Comprehensive Audit:

1. Name of the Sub-Station: 220 KV Namrup GSS
2. Voltage level: 220 KV/132 KV
3. Owner: AEGCL
4. Date of Audit: 13.11.2021
5. Members of Auditing Team:

Audit Observations / Recommendations of 220/132/66 KV Namrup

Station Name: 220 kV Namrup Substation Audit Report

Single Line Diagram of 220/132/66/33 kV Grid Substation,
AEGCL, NTPS, Namrup

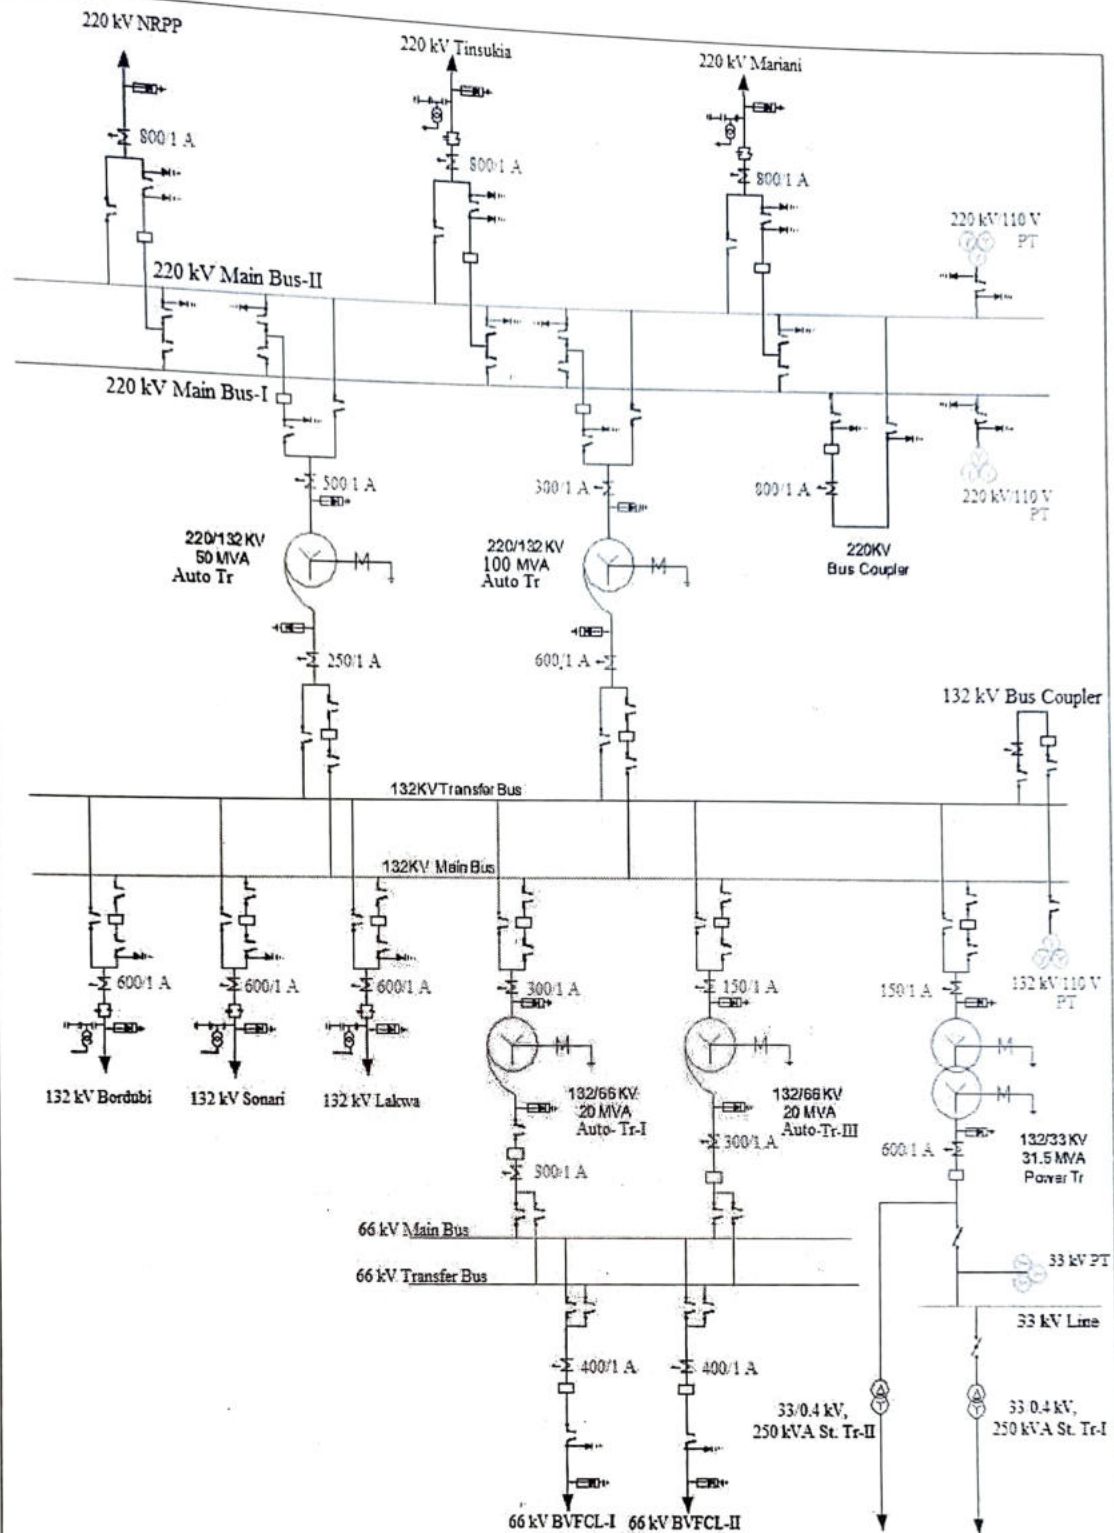
Isolators indicators not responding.

① 89 AE { ~~Related~~
② 89 B { 220/132 kV 50 MVA }

③ 89 T {
④ 89 A { 132 kV TBE }

⑤ 89 T (Lakma feeder — Transfer bus)
⑥ 89 T (Sonari feeder — Transfer bus)
⑦ 89 T (Bordubi feeder — Transfer bus)

⑧ 89 LE (132/33 31.5 MVA)

⑨ 89 LE (132/66 kV 20 MVA III)

⑩ 89 B (220/132 kV 100 MVA)

⑪ 89 PTA (132 kV Bus PT)

⑫ 89 A (66 kV BVFCL I)
